Access Compliance Report

Public Rights-of-Way

Intersection ID: 31202	Main Street: OAKTON_HUNT_DR	Cross Street: WRAYHILL_DR	Location: W
ADA ID: AC248B2B368D	Ramp Type: PerpDiag	Initial Pass/Fail: Fail	Overall Compliance: No
			Severity Score: 33.75

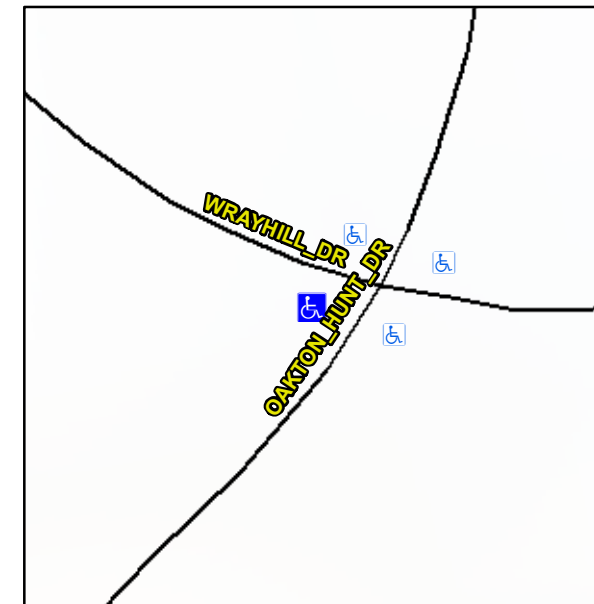
Not Found, R304.5.1, R304.5.3

Compliance	Description	Data	Compliance	Description	Data
N/A	Ramp Length (in)	48.0	Yes	Ramp Slope (%)	8.0
No	Ramp Width (in)	47.0	No	Ramp XSlope (%)	9.9
N/A	Flare Type LT	N/A	N/A	Flare Type RT	N/A
N/A	Flare Slope LT (%)	N/A	N/A	Flare Slope RT (%)	N/A
N/A	Flare Traversable LT?	N/A	N/A	Flare Traversable RT?	N/A
N/A	Landing Length (in)	N/A	N/A	DWS Provided?	N/A
N/A	Landing Width (in)	N/A	N/A	DWS Contrast?	N/A
N/A	Landing Slope (%)	N/A	N/A	DWS Length (in)	N/A
N/A	Landing X Slope (%)	N/A	N/A	DWS Full Width?	N/A
N/A	Landing Curb? (Y/N)	N/A	N/A	DWS Offset (in)	N/A
N/A	Shared Landing?	N/A			
N/A	Gutter Ponding?	N/A	N/A	Gutter Slope (%)	N/A
N/A	Gutter Lip Ht (in)	N/A	N/A	Gutter X Slope (%)	N/A
N/A	Painted X Walk1?	No	N/A	Painted X Walk2?	No
	X Walk 1 Direction	To SE		X Walk 2 Direction	To NE
N/A	X Walk 1 Width (in)	N/A	N/A	X Walk 2 Width (in)	N/A
	X Walk 1 Slope (%)	3.2		X Walk 2 Slope (%)	2.2
	X Walk 1 X Slope (%)	4.5		X Walk 2 X Slope (%)	6.3

Remove & Replace Curb Ramp With Two New Directional Ramps or Equivalent.
